ADDENDUM NO. 1

December 2, 2021

Cadillac High School Addition & Renovations

This Addendum forms a part of and modifies the Bidding Requirements, Contract Forms, Contract Conditions, the Specifications, and the Drawings dated November 3, 2021, by TowerPinkster. Acknowledge receipt of the Addendum in the space provided on the Bid Form. Failure to do so may subject the Bidder to disqualification.

SHEET NUMBER
G 001.2
17-175.70

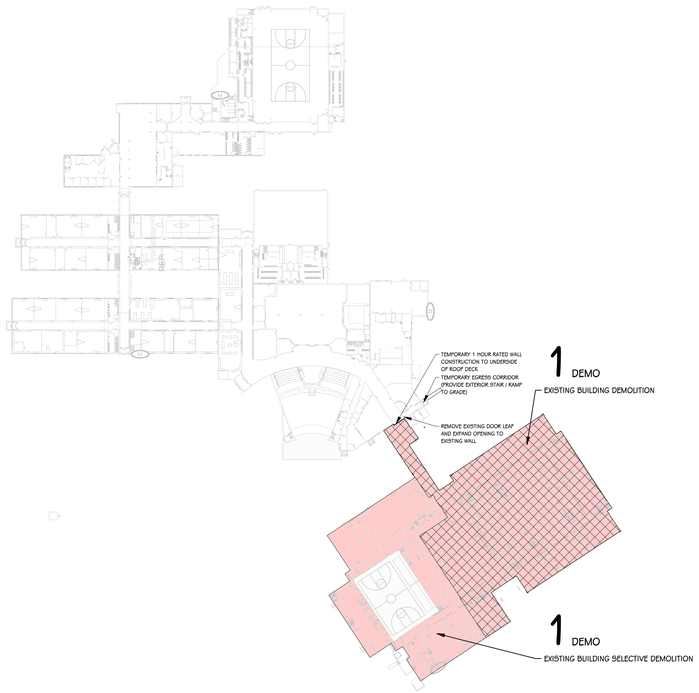
ADD-1 Item No. D-1 - Alternates Revisions

Revised list of alternates.

2 / G100.2B — FIRST FLOOR CONSTRUCTION PHASING PLAN - PHASE 1 DEMOLITION
1" = 80'-0"

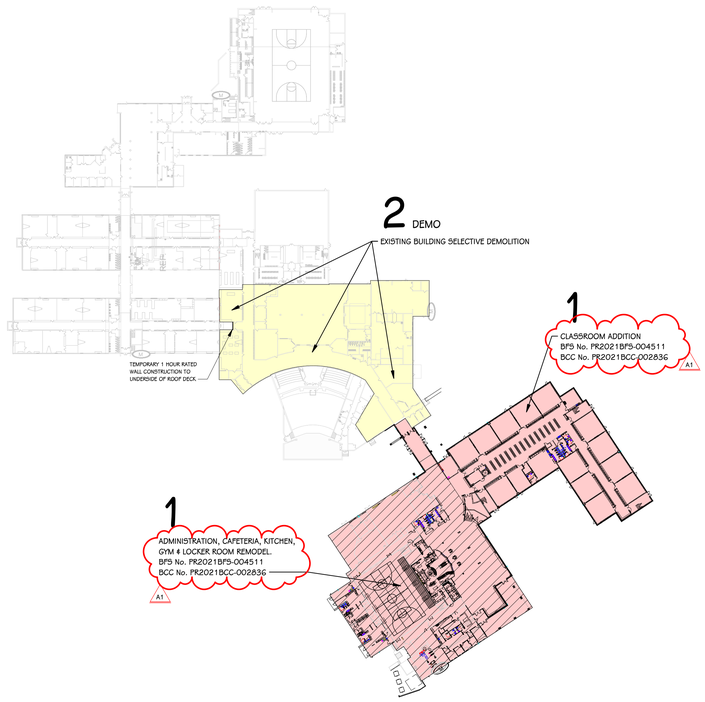
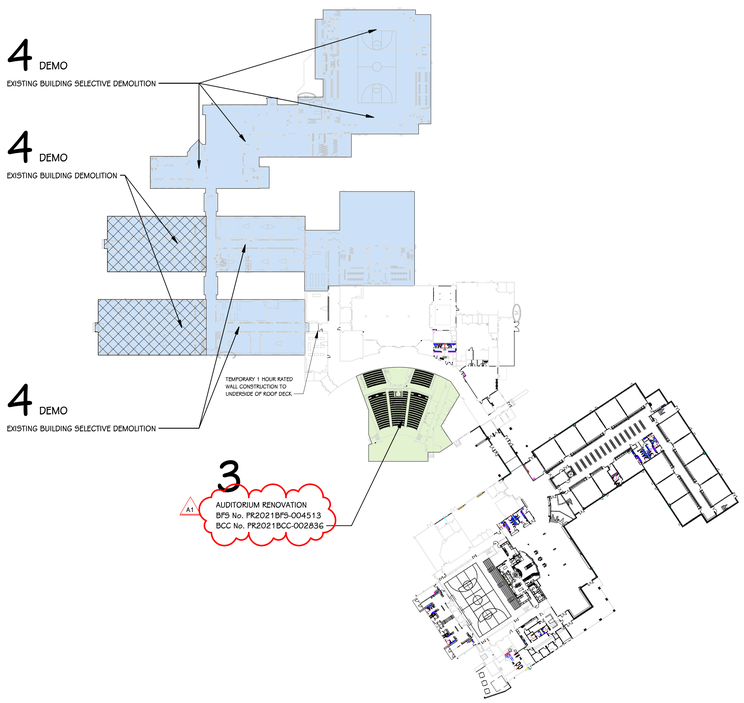
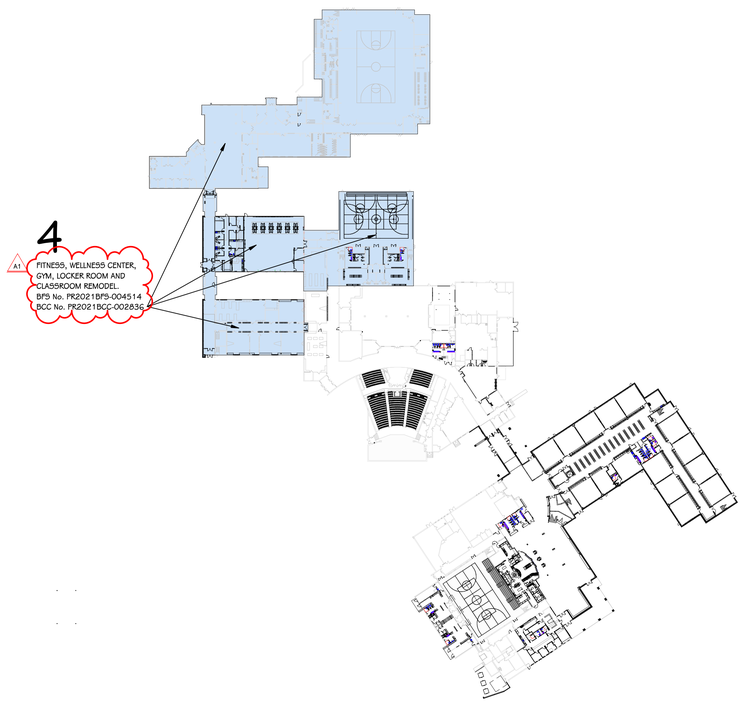
ADD-1 Item No. D-2 - BCC and BFS Numbers

3 L 003.2 **CHAIN LINK FENCE DETAIL**
1/2" = 1'-0"

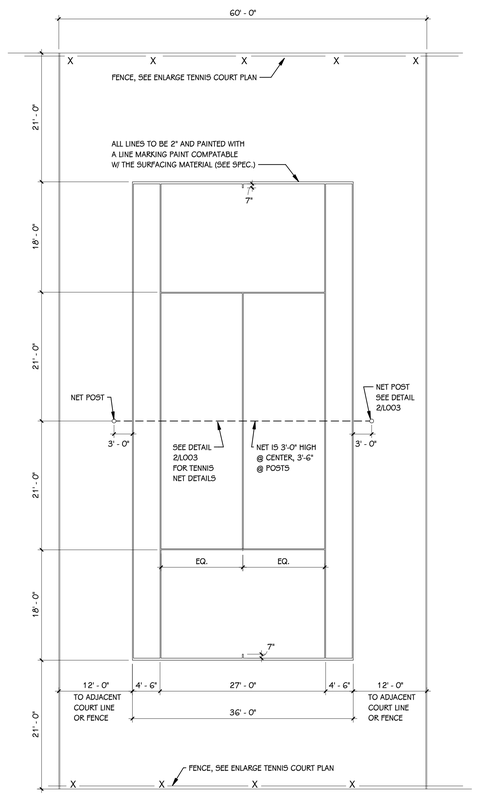
Added detail key callouts referencing chain link fence Detail 3/L 003.2.

Added detail key callout on Detail #13 – Track Section. Callout references chain link fence to Detail 3/L 003.2.

SHEET TITLE
FIRST FLOOR PLAN - UNIT D

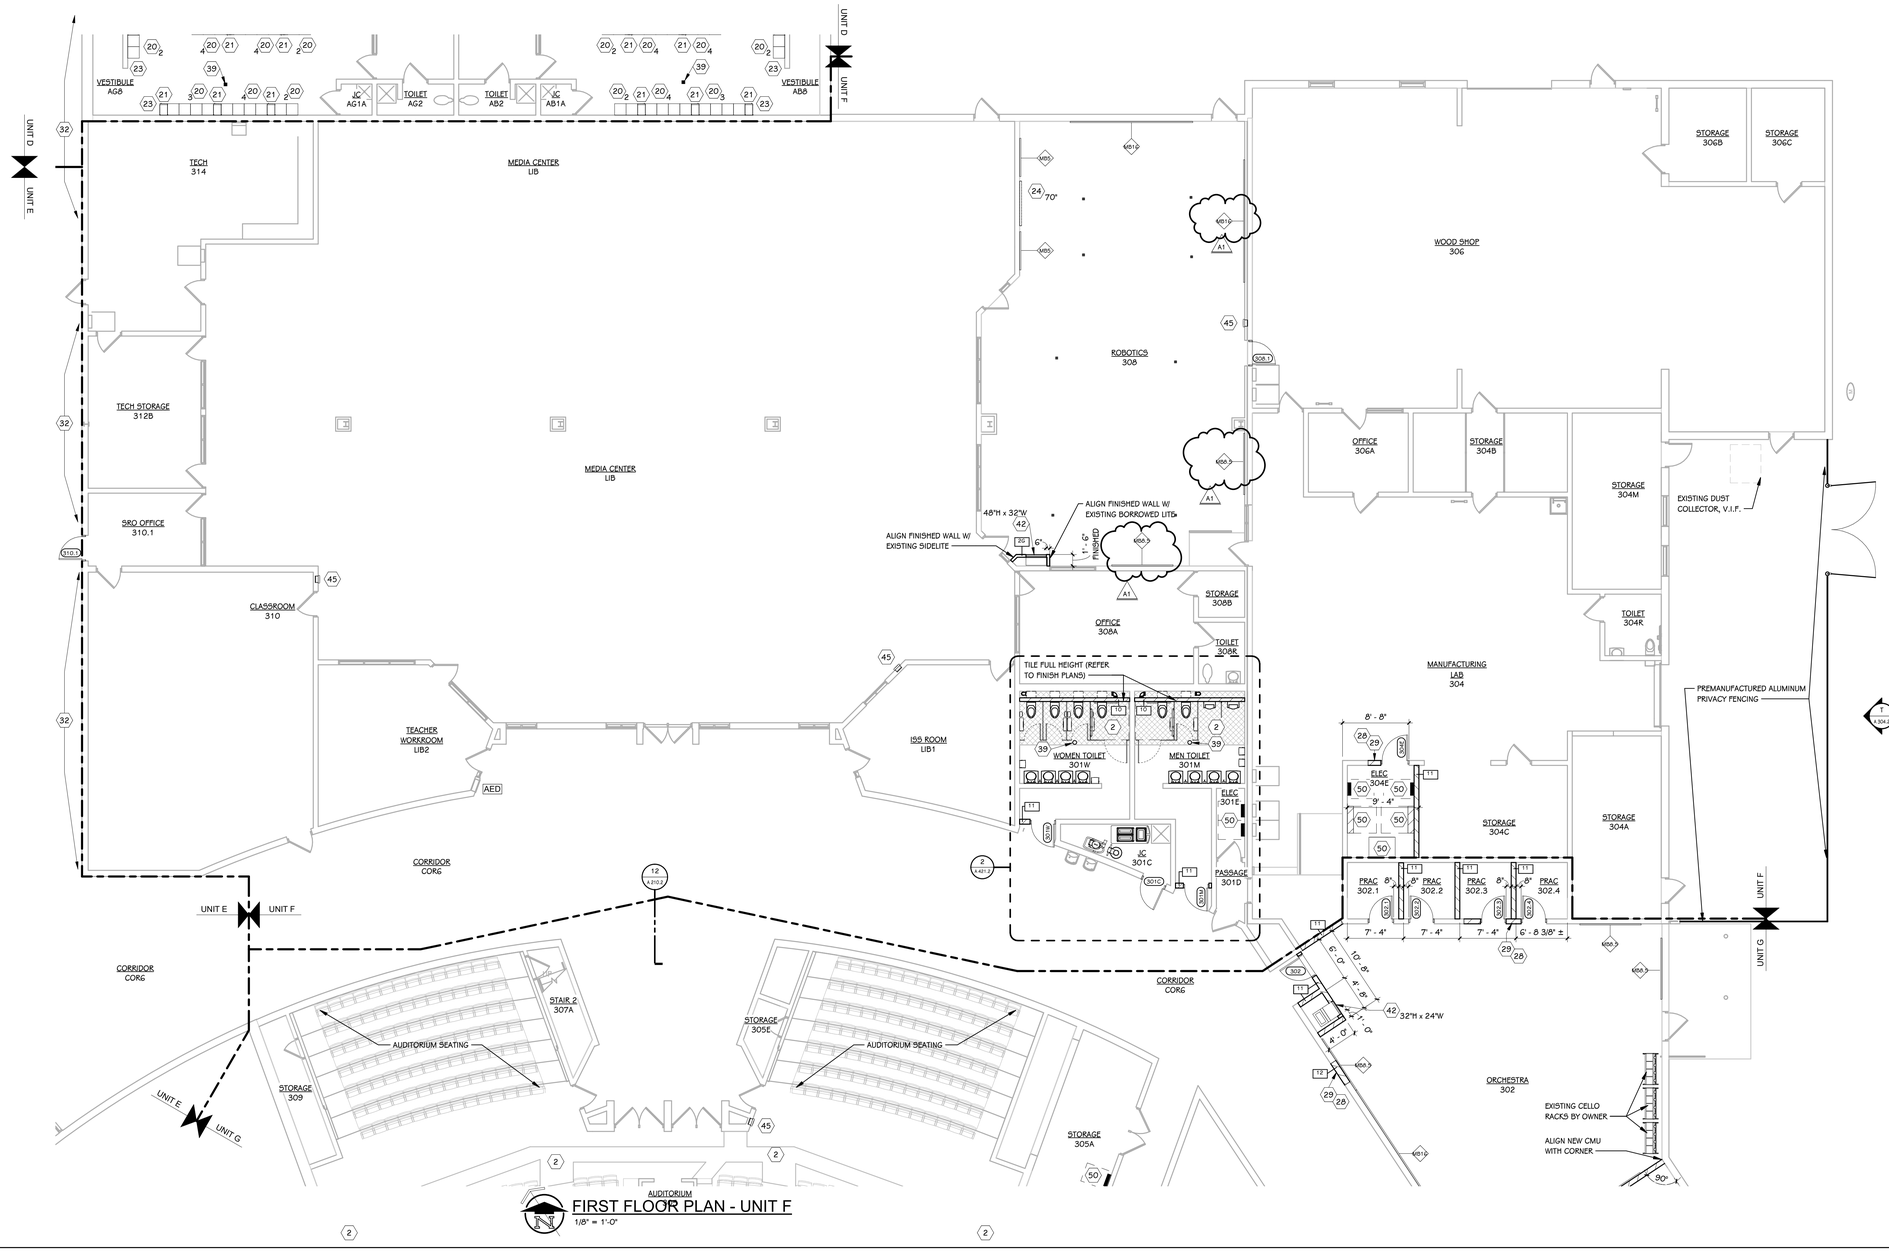
ADD-1 Item No. D-7 - Slab-on-Grade Removal and Replacement

Remove additional portion of existing slab-on-grade for removal and replacement of underground storm piping (refer to Plumbing drawings), and installation of new concrete slab-on-grade. As shown clouded.

SHEET NUMBER A 101.2F

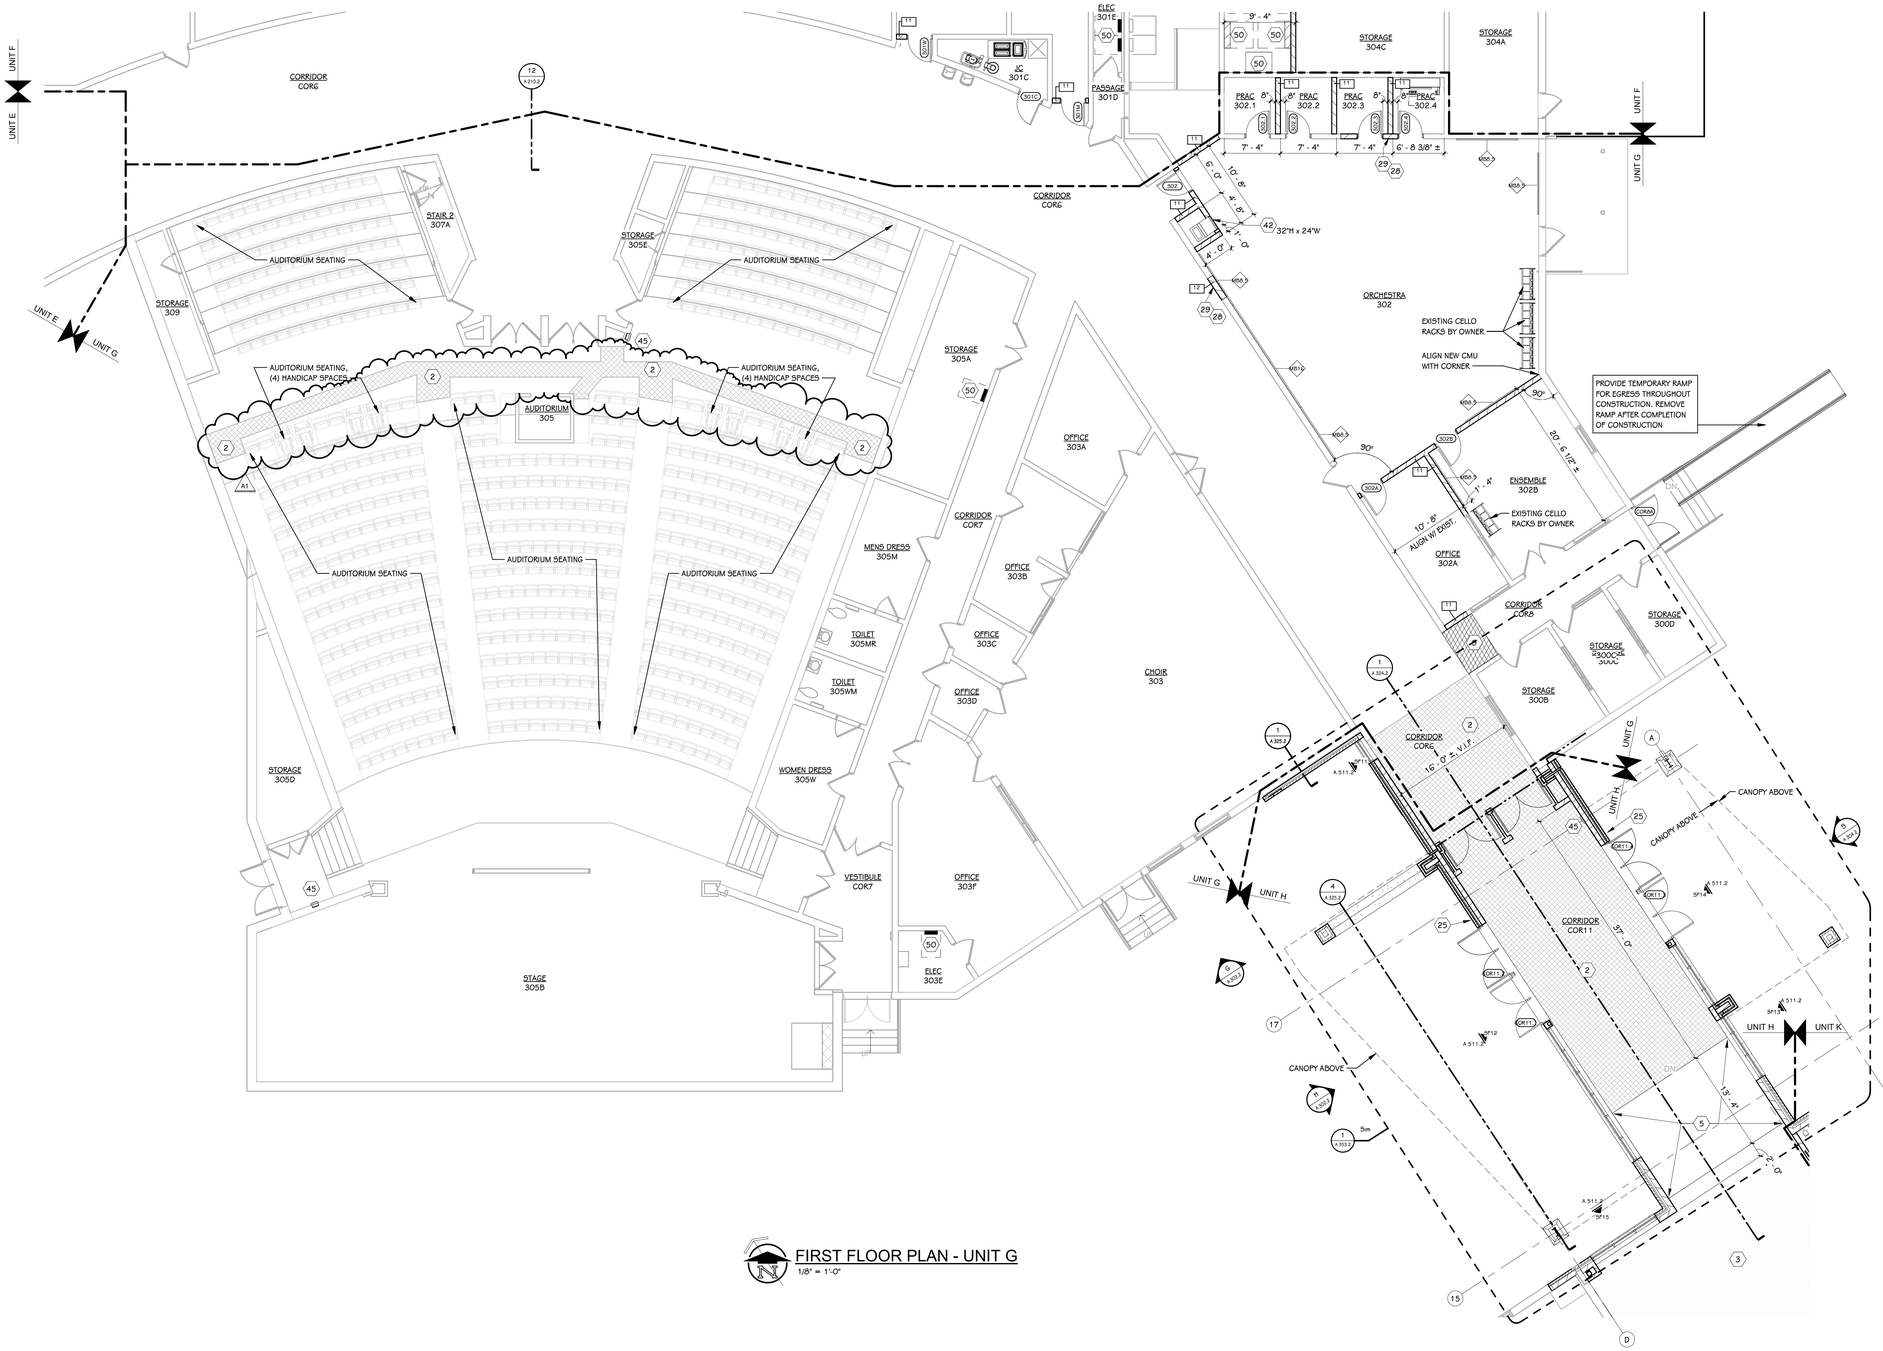
Refer to Sheet(s): A101.2F and A633.2.

37 A 634.2 AUDITORIUM - WEST
1/4" = 1'-0"

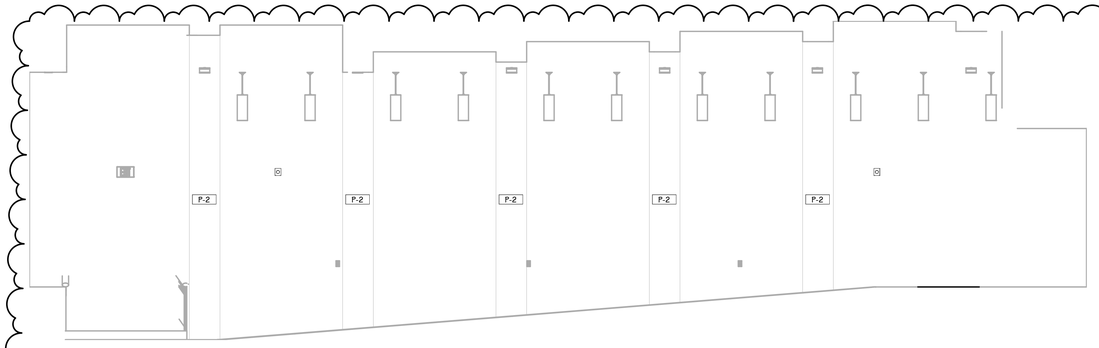
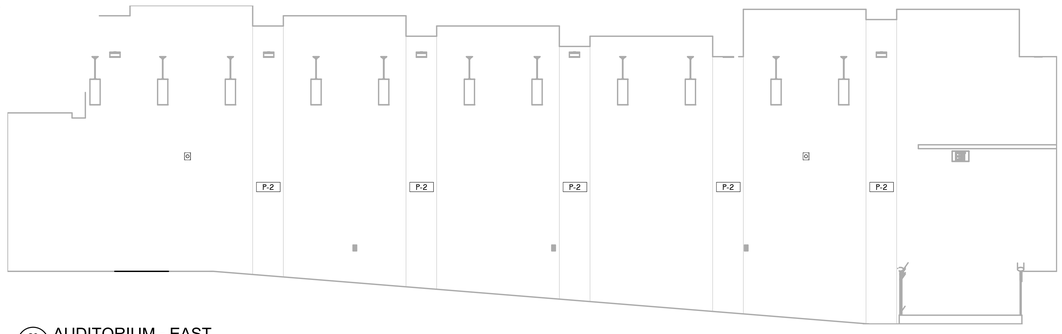
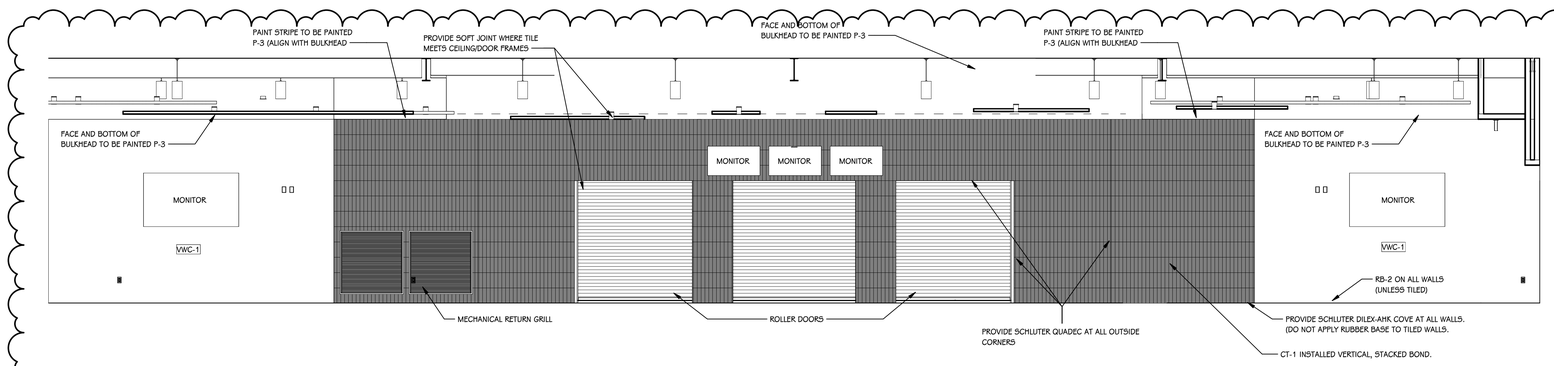
Refer to Sheet(s): A634.2, A653.2, and A654.2

FIRST FLOOR PLUMBING PLAN - UNIT J
1/8" = 1'-0"

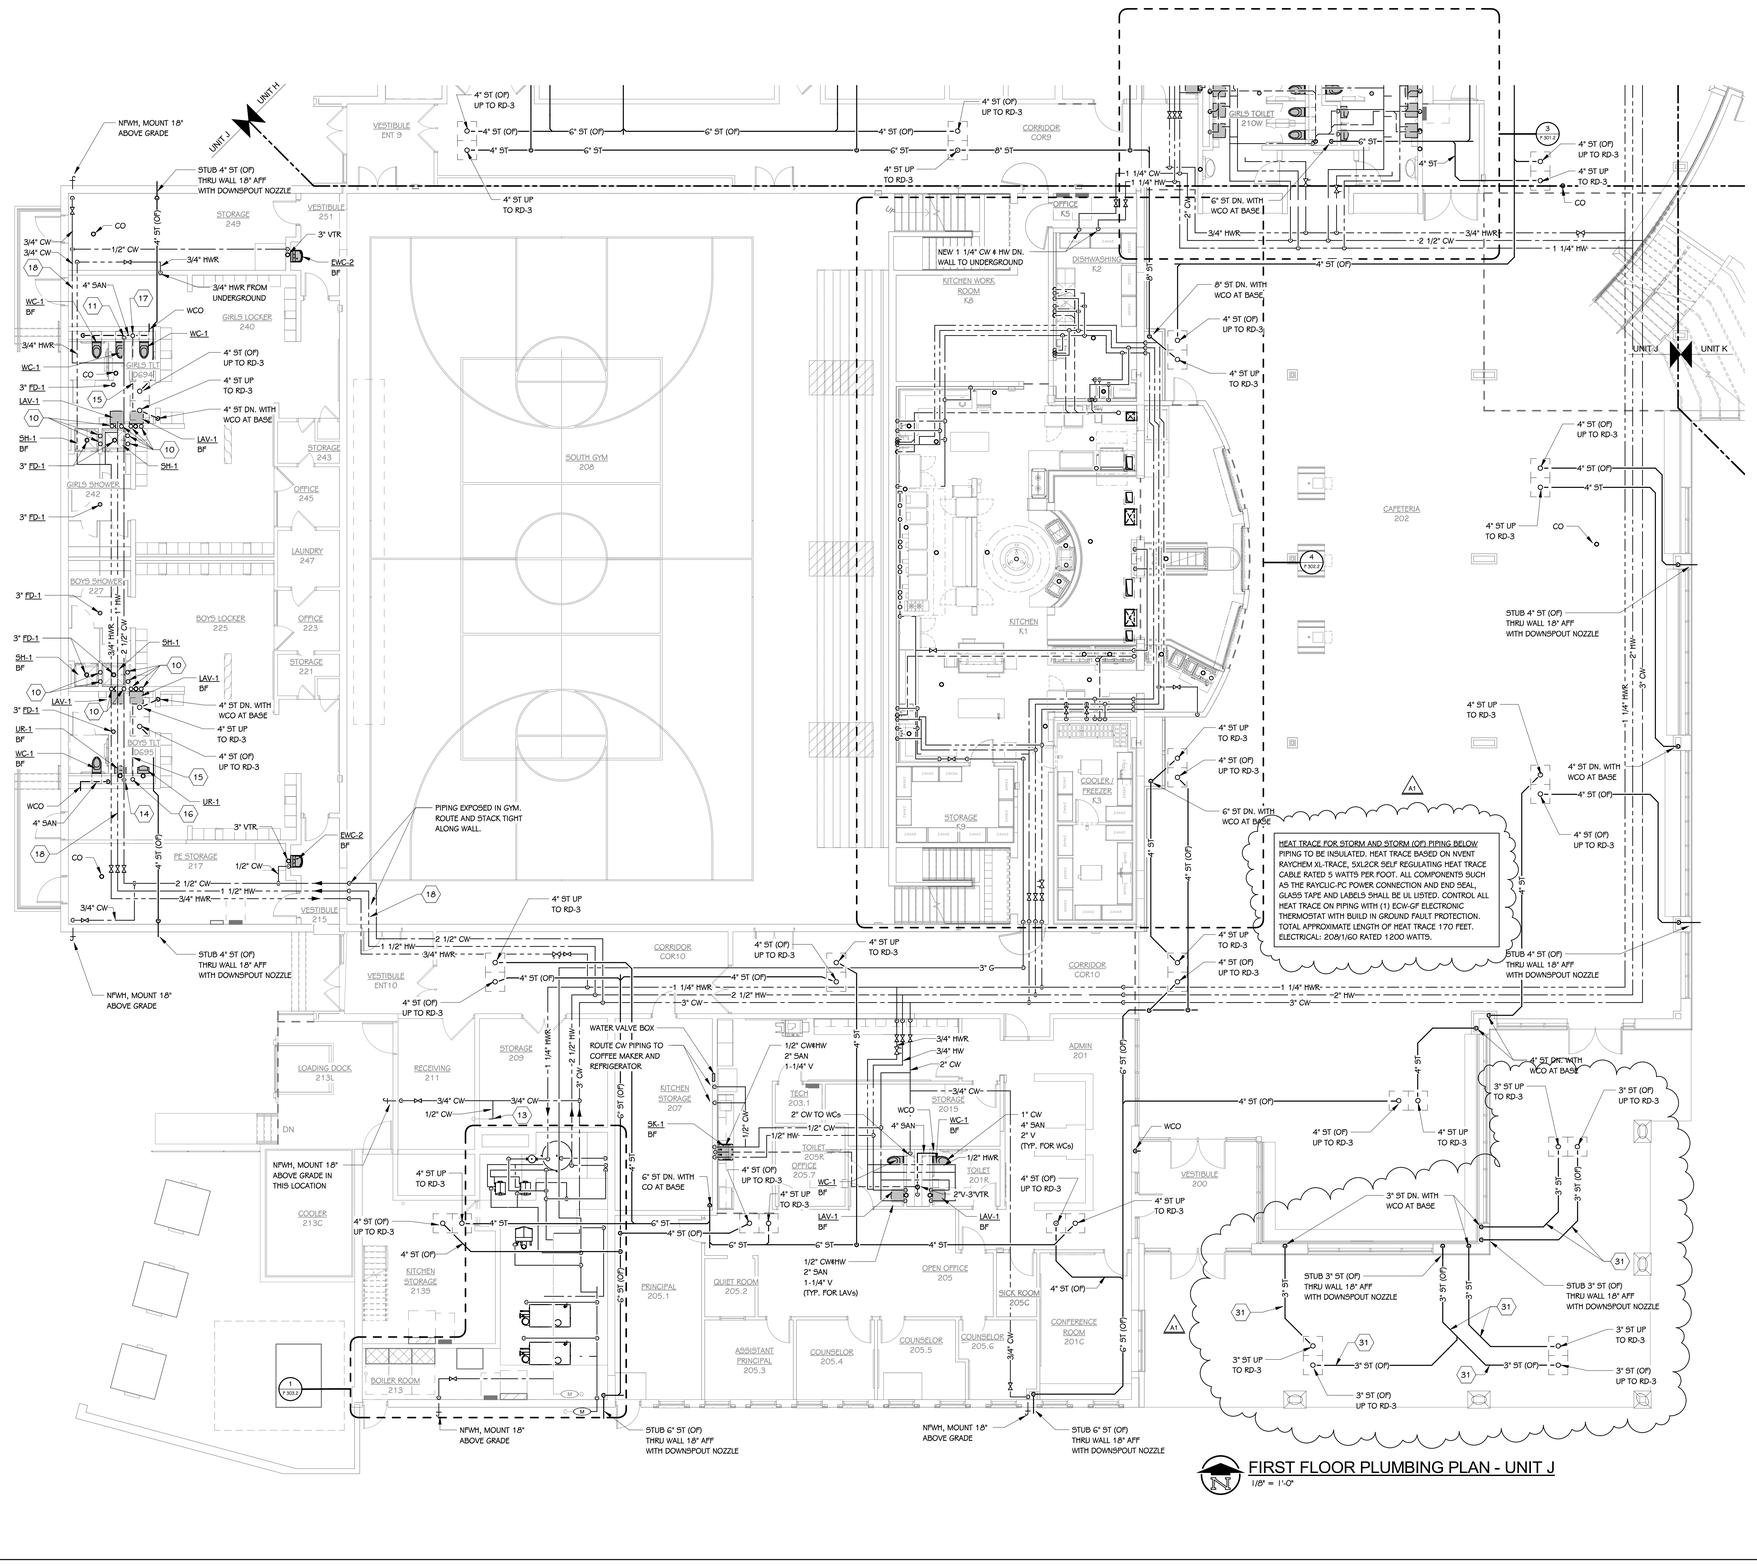
Refer to Sheet: P 101.2J
